6210 CORY-BRET LN

Groundwater and Wastewater Services File Imaging Project

Mecklenburg County
Health Department

RE: Property located at 6210 Cory Bret Lane
FILE: 4386A
PARCEL: 199-231-03 PO

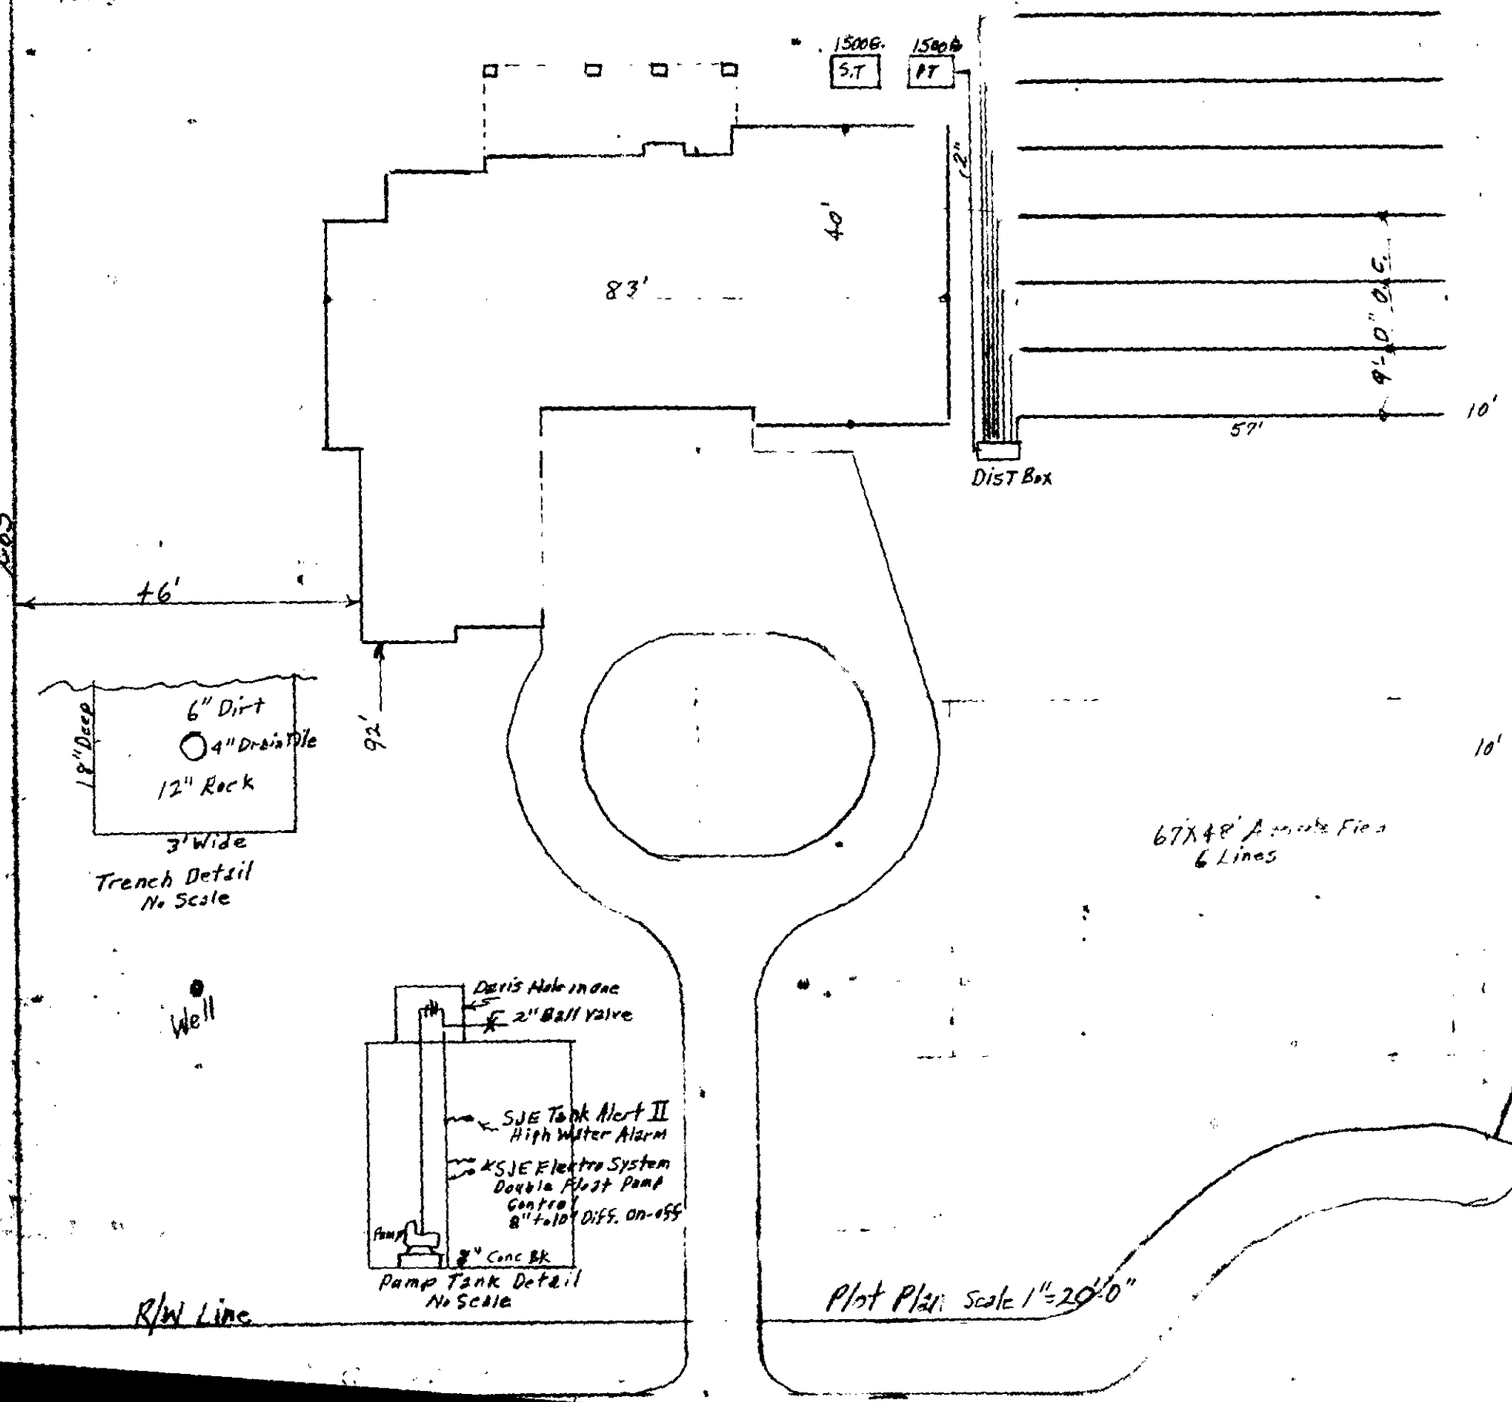
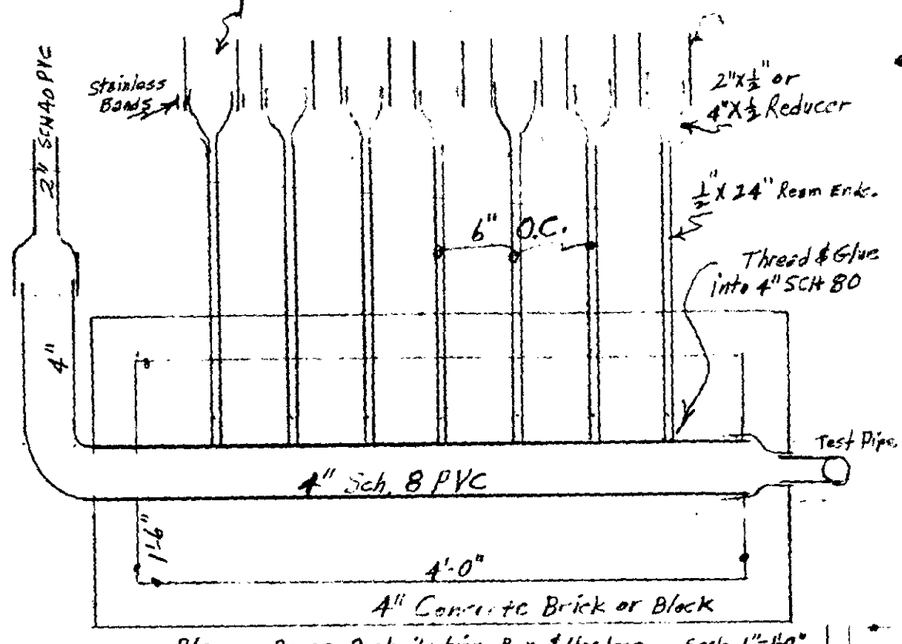
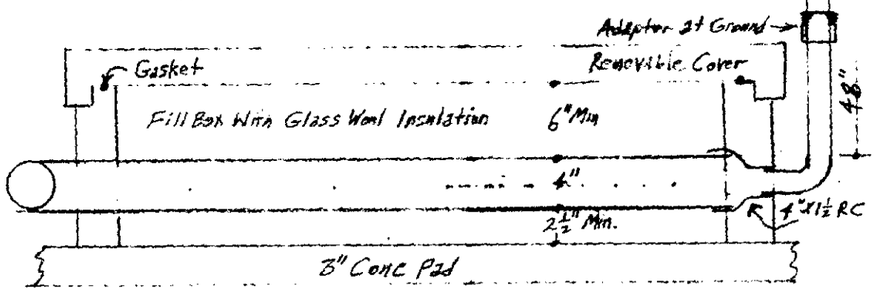
Your plans for the modified system for the above property as submitted are approved with the following comments:

- The well should be located 100 feet or no less than 50 feet away from any part of the sewage disposal system and repair area.
- Water saving plumbing devices and low flush or microflush toilets must be installed when constructing the residence.
